VOLUME 2 OF 2 - ZONING

# Summary of Comments on P:\Projects\1216-00\BIM\Revit \Families\TITLEBLOCKS\EXTELL Proposal\_atwalj.pdf

Summary of Comments on FP-401.00

## Summary of Comments on AAI-TWR-ARCHITECTURE- CANTILEVER\_namrudl.rvt

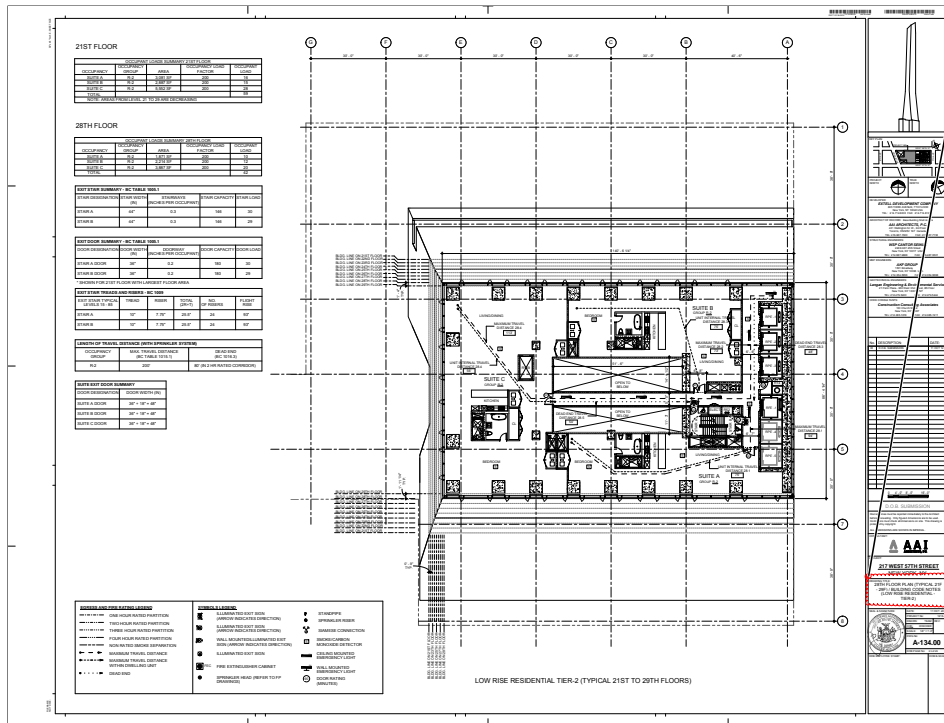
Author: dtitus Subject: Polygon Date: 1/7/2013 9:31:18 AM  
The common path of egress travel shall not exceed 125 feet as per BC 1013.3. The maximum length of exit access travel, measured from the most remote point within a story/space to the entrance to an exit along the natural and unobstructed path of egress travel, shall not exceed the distances given in BC Table 1015.1.

Author: dtitus Subject: Polygon Date: 1/7/2013 9:30:14 AM  
BC 908.7.1.2 Provide notes to indicate compliance for carbon monoxide detectors.  
Indicate location of smoke/ carbon monoxide detectors. (TYP.)

Author: dtitus Subject: Polygon Date: 1/4/2013 10:06:27 AM  
Provide refuse chute details: [2 hr fr walls & roof] and compliance with BC 1213.3 and BC 707.13  
Refuse storage room to comply with BC 1213.1  
Provide proper enclosure and details  
Provide UL # for system or fire hopper doors  
Compliance with BC 1101.2;

Author: dtitus Subject: Polygon Date: 1/4/2013 10:41:39 AM  
Provide note describing stairway door operation and stairway communications system as per BC 403.12  
Provide note describing smoke proof exit enclosures for compliance with BC 403.13.  
Provide note describing impact-resistant stairs enclosures as per BC 403.15  
Provide exit lighting and directional signs (lighting) & (egress) as per BC 1006, BC 1011, BC 1026 (both EG and Construction plans)

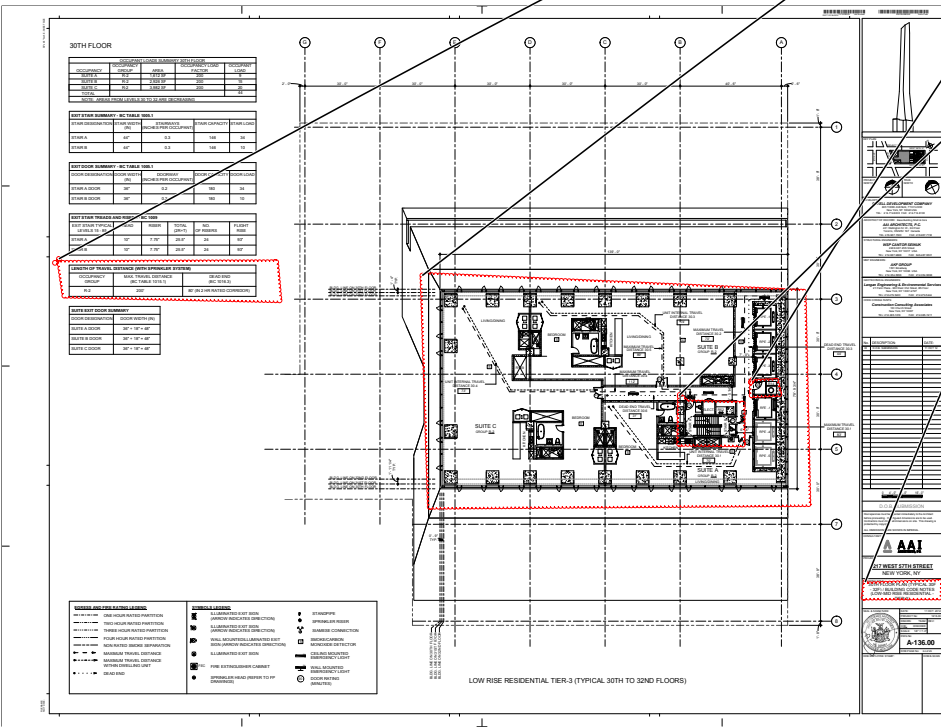
Author: dtitus Subject: Polygon Date: 1/4/2013 10:05:14 AM  
Please indicate as Typ. 30-32nd Floor Plans

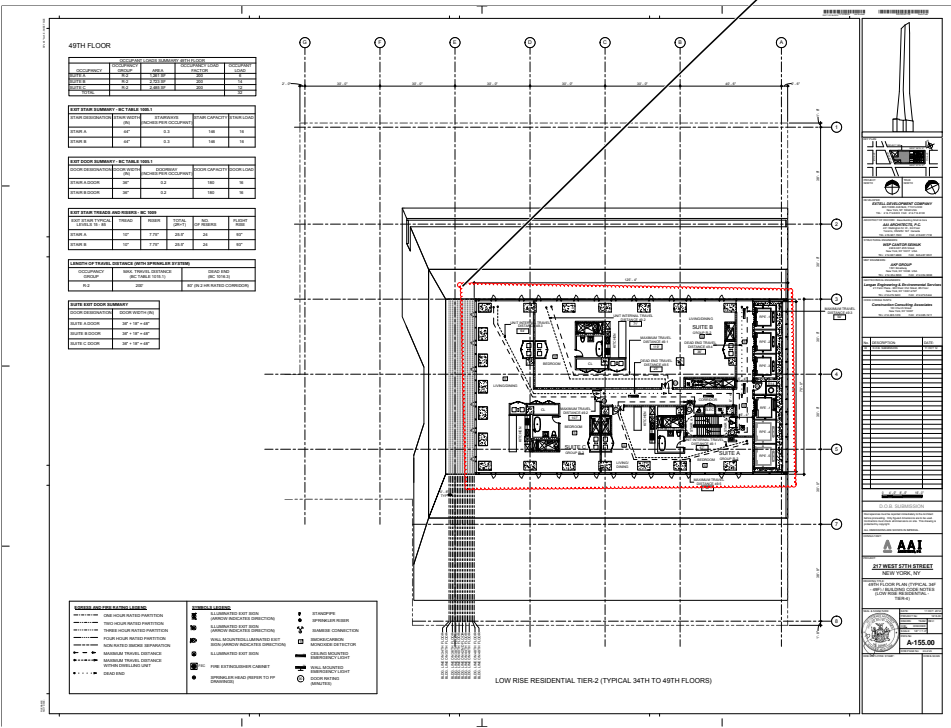
BC 1101.1, 1101.2, and  
ICC/ANSI A117.1-2003 Verify compliance with accessibility as per BC 1101  
Primary access- 1105  
Doors & maneuvering clearances-1107.2.1  
Residential bathrooms – 1107/ Appendix P  
Residential kitchens – 1107.  
Show all grab-bars including vertical as per P102.8.3.1,  
Walk-in closets  
Access to W/D within units  
**TYP. all R-2 floors**

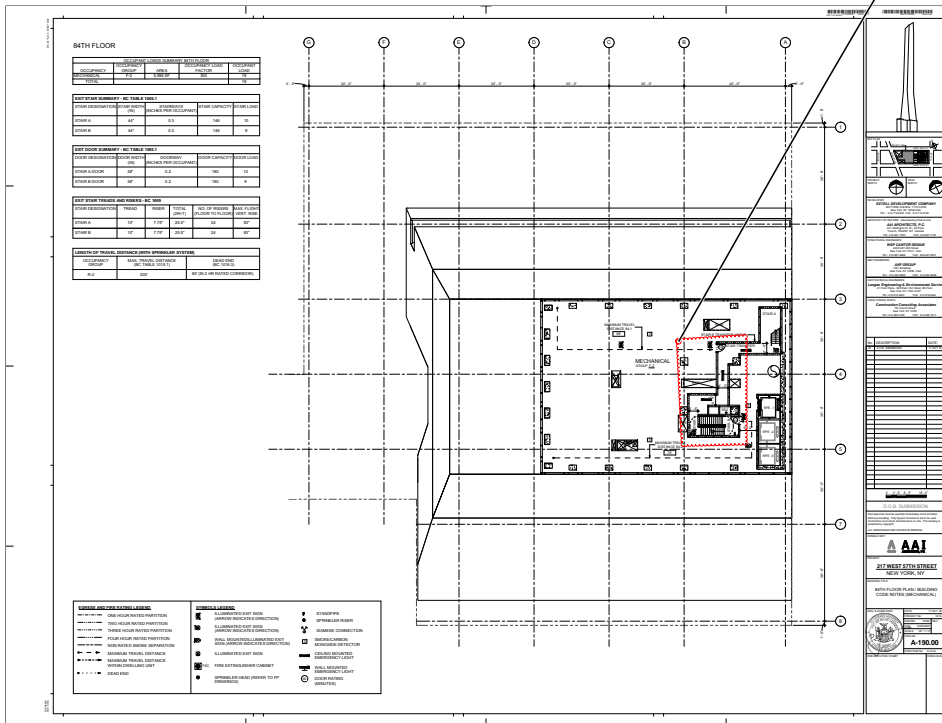
Author: dtius Subject: Polygon Date: 1/4/2013 10:08:37 AM  
A-occupancy

BC 403.11.1 Emergency power systems for *assembly occupancy*

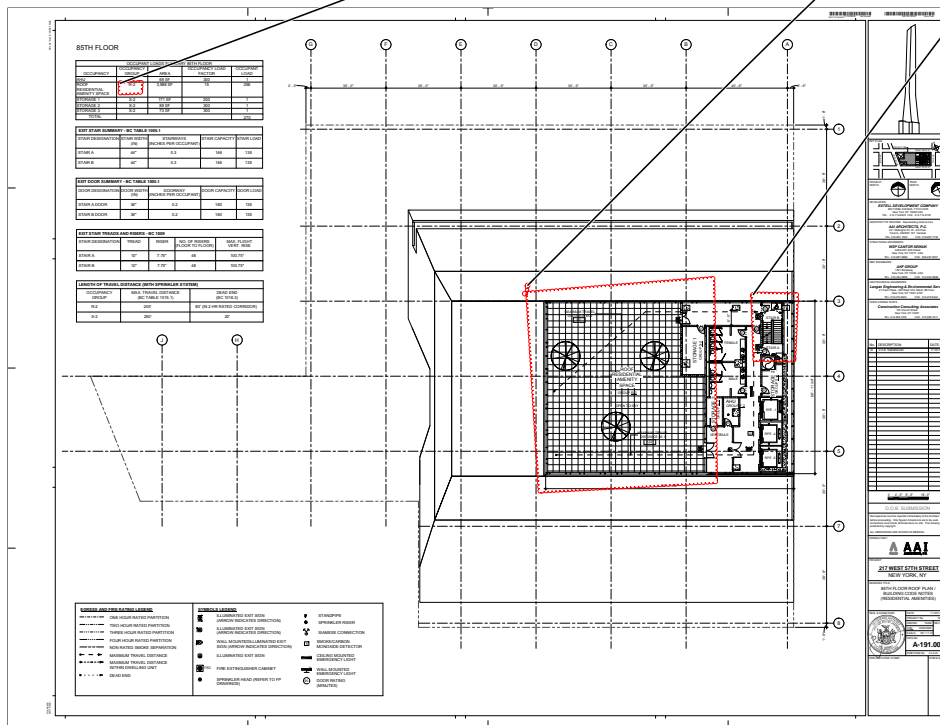
- 04-16-13
1. Exit signs and means of egress illumination required by chapter 10;2.  
3. emergency voice communications systems; and  
4. Electrically powered fire pumps, unless electrical power to the motor is taken ahead of the main from the street side of the service switch.

Author: dtitus Subject: Polygon Date: 1/2/2013 11:59:00 AM  
All interior stairs must lead to the roof as per BC 1009.12

All interior stairs must lead to the roof as per BC 1009.12

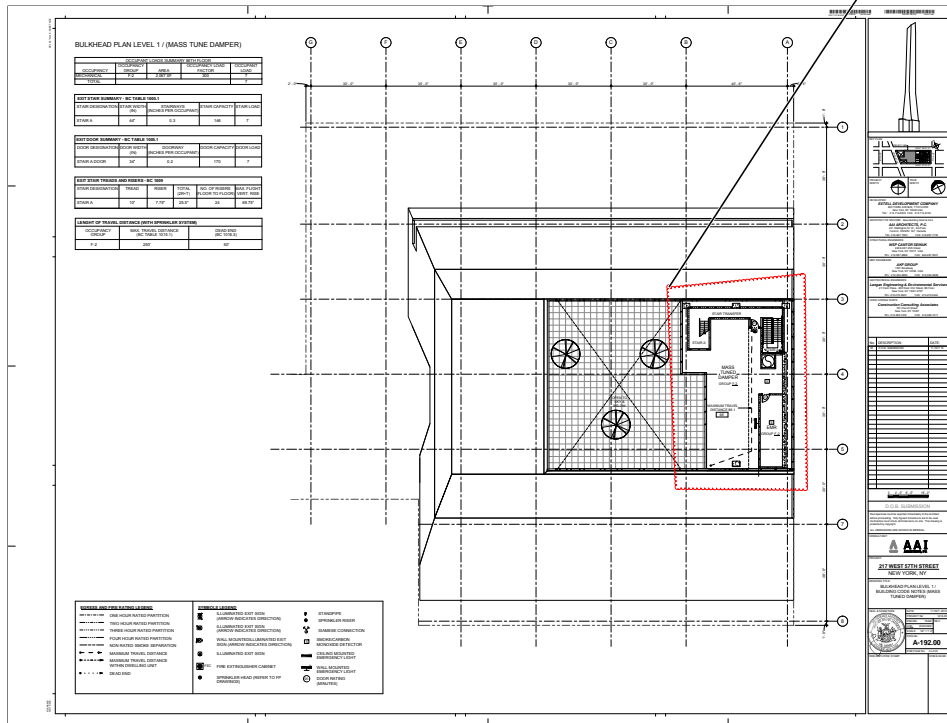
Show compliance with the requirements for elevator clearances (top & bottom) and runbys for cars and counterweight.

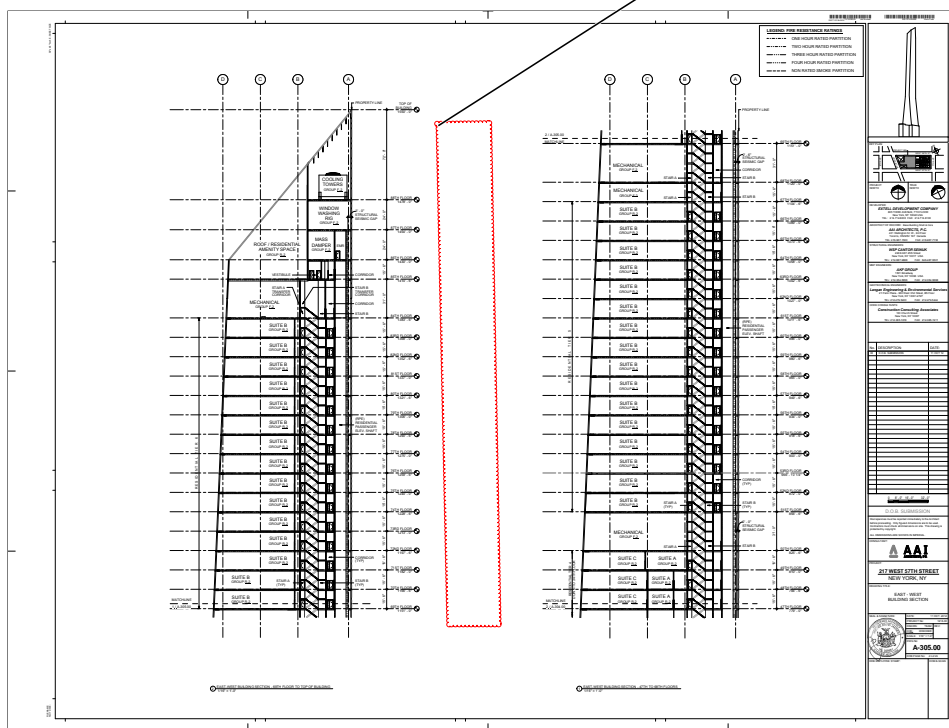
Provide all schedules windows, doors (indicate FPSC on all fire rated doors) etc.

Provide structural peer review report as per BC 1627.

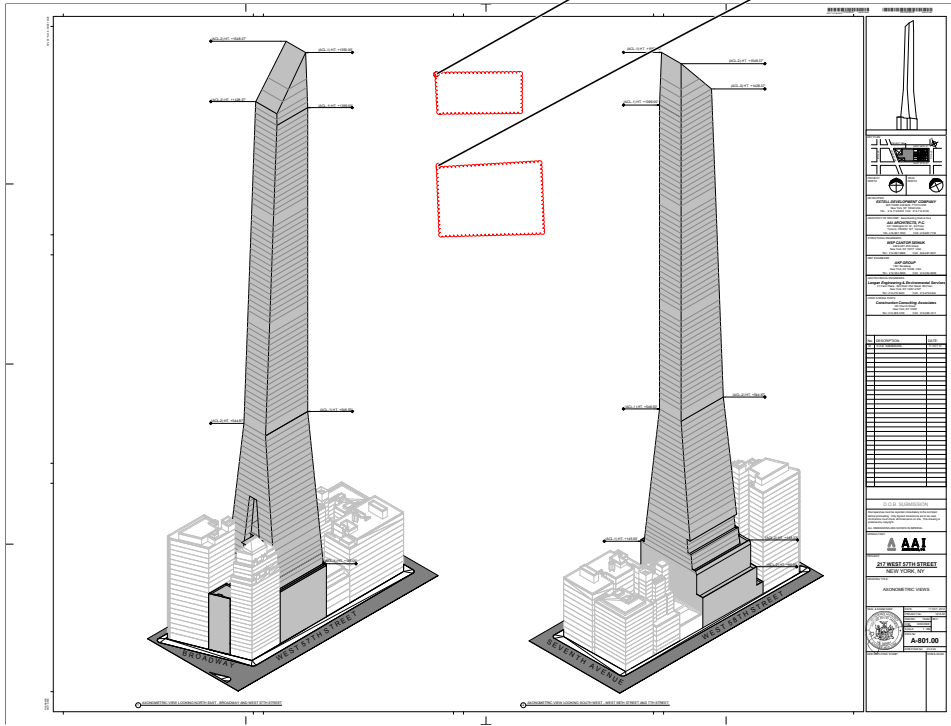
Provide building elements, exterior walls of non-combustible construction with fire-resistance ratings for Type I-B construction (BC 602.1, BC 602.2).

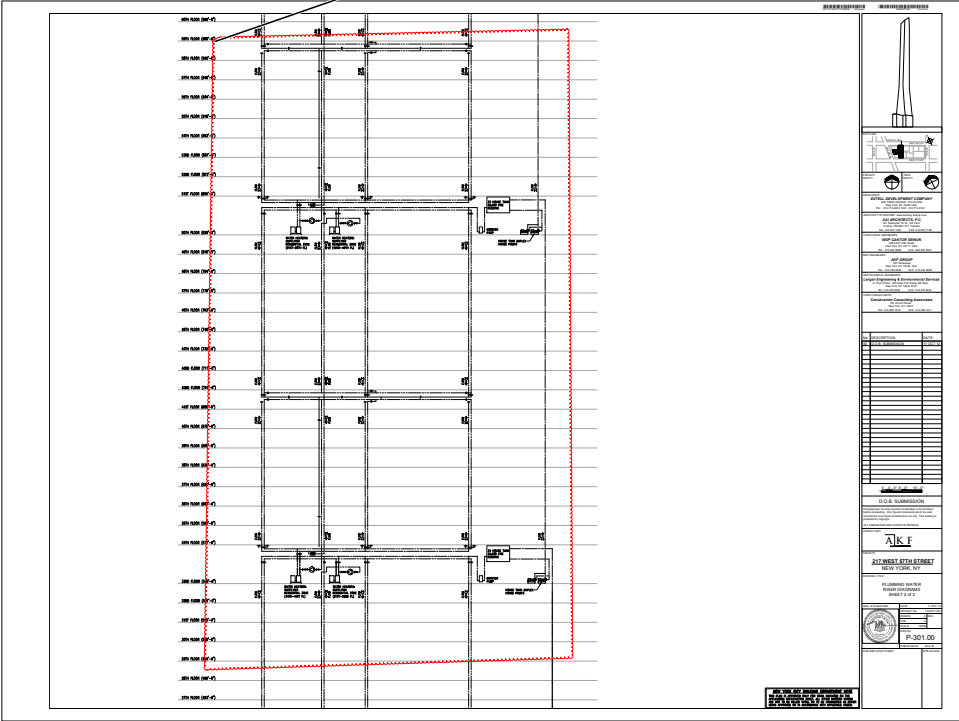
Author: dtitus Subject: Polygon Date: 1/8/2013 9:12:55 AM  
Please provide a complete water and gas riser diagram.

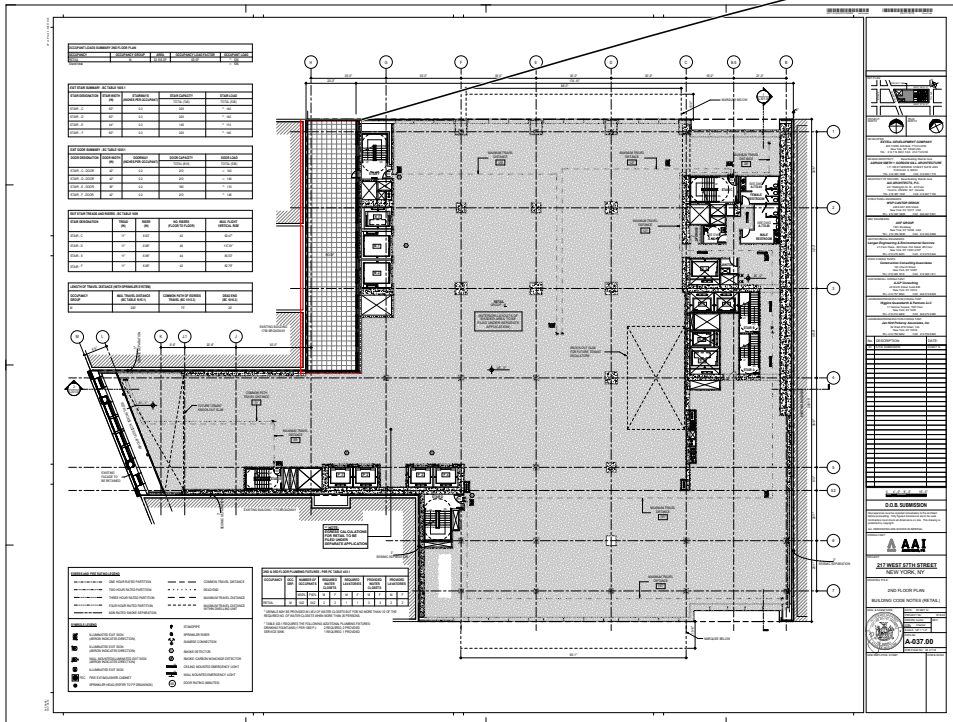
Provide net area of space and number of persons to be accommodated based on (15) sq. ft./person as per table 1004.1.2 BC

Provide the required number of exits per space, per maximum occupant load as per Table 1014.1.

Provide exit lighting and directional signs (lighting) & (egress) as per BC 1006, BC 1011, BC 1026 (both EG and Construction plans)

roof no occ. 11-18-14

NO occ. 11-18-14

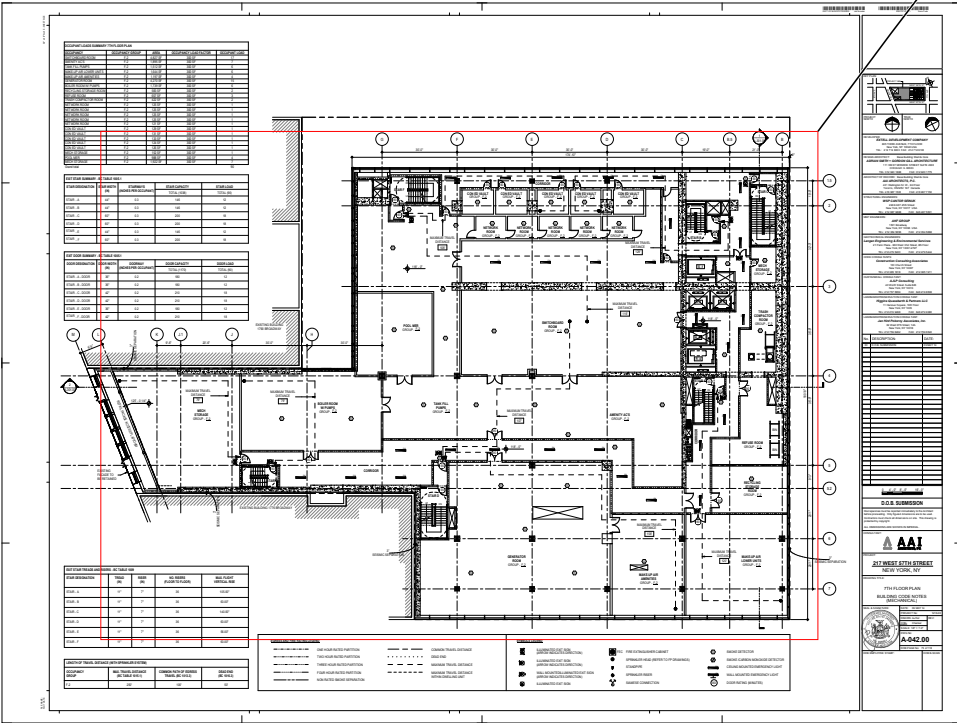
Author: dtitus Subject: Rectangle Date: 10/7/2014 8:25:25 AM  
TABLE 403.1 Provide table for plumbing fixtures to comply with table. 403.1. Provide calculations within each space, 11-18-14

Provide the required number of exits per space, per maximum occupant load as per Table 1014.1. 01-12-15

Provide the required number of exits per space, per maximum occupant load as per Table 1014.1. 11-18-14

Author: dtitus Subject: Rectangle Date: 10/7/2014 8:03:54 AM  
A-2 occ. 01-12-15

Author: dtitus Subject: Rectangle Date: 10/7/2014 8:03:24 AM  
R-2 occ. 11-18-14

Provide the required number of exits per space, per maximum occupant load as per Table 1014.1. 01-12-15

Author: dtitus Subject: Rectangle Date: 10/7/2014 8:28:30 AM  
Provide exit signs as per BC 1006, BC 1011, BC 1026 (both EG and Construction plans) 11-18-14

Author: dtitus Subject: Rectangle Date: 10/7/2014 8:45:47 AM  
Propose swimming pool not located within a building does not meet the requirements of ZR 12-10 accessory use (5), (ii).

11-18-14 pool below roof line.  
see A021 for compliance

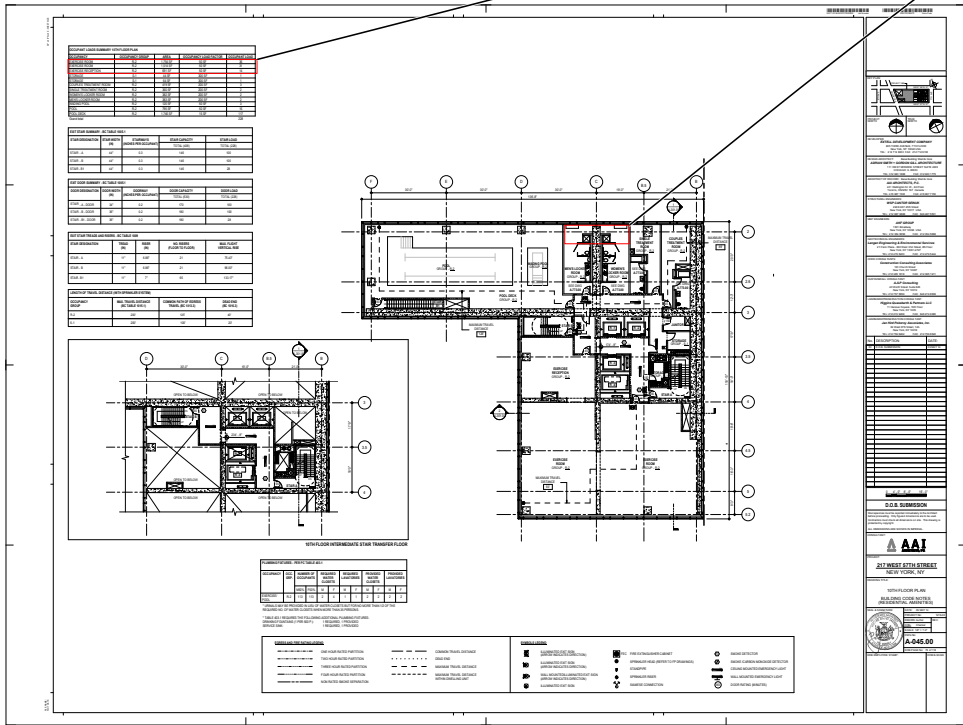
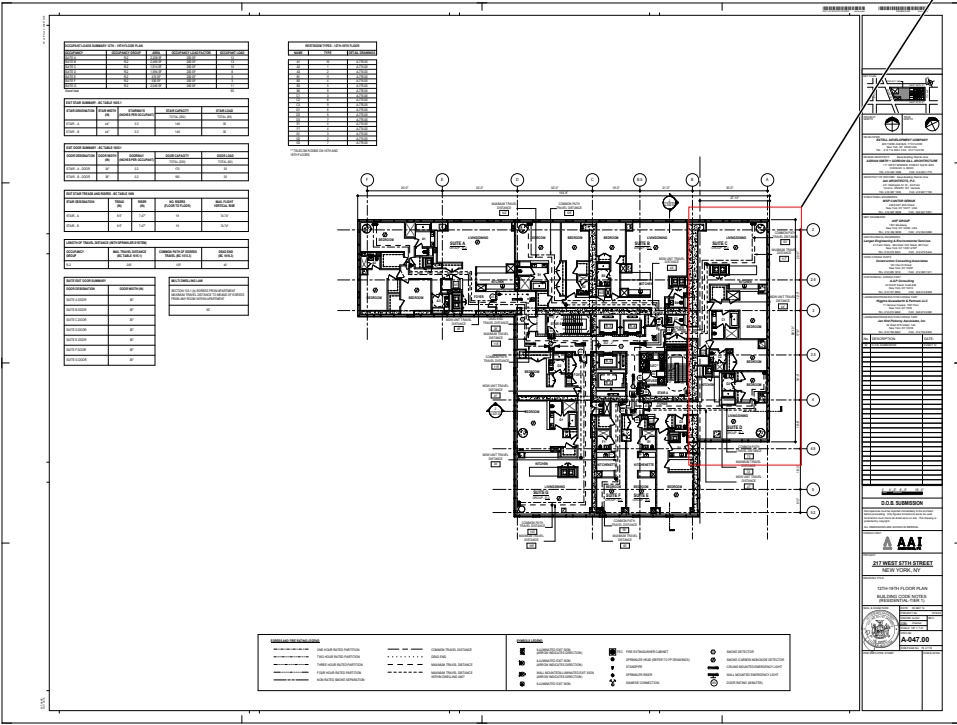
Author: dtitus Subject: Rectangle Date: 10/7/2014 9:10:59 AM  
one space A- occupancy.

Author: dtitus Subject: Rectangle Date: 10/7/2014 9:12:42 AM  
owers not permitted if acc. to R occupancy.

BC 1101.1, 1101.2, and  
ICC/ANSI A117.1-2003 Verify compliance with accessibility as per BC 1101  
1. Doors & maneuvering clearances-1107.2.1  
2. Residential bathrooms - 1107/ Appendix P  
3. Residential kitchens - 1107

5. Walk-in closets

6. Access to W/D within units (Where washing machines or clothes dryers are provided within the dwelling or sleeping unit, such equipment shall comply with Section 611 (Washing Machines and Clothes Dryers) of ICC A117.1 and shall be front loading. Laundry equipment in accessible common-use areas as required in Section 1107.3 shall comply with Section E105.3. (TYP ALL R-2 Floors)

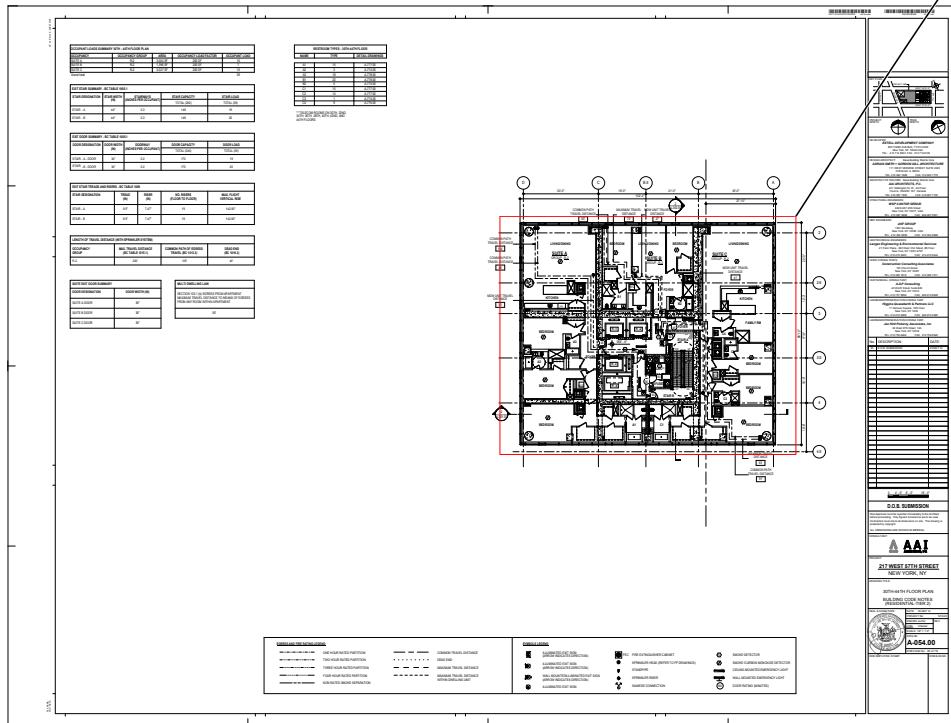
3.Residential kitchens – 1107.

4.Show all grab-bars including vertical as per P102.8.3.1,

5.Walk-in closets

6.Access to W/D within units (Where washing machines or clothes dryers are provided within the dwelling or sleeping unit, such equipment shall comply with Section 611 (Washing Machines and Clothes Dryers) of ICC A117.1 and shall be front loading. Laundry equipment in accessible common-use areas as required in Section 1107.3 shall comply with Section E105.3. (TYP ALL R-2 Floors)
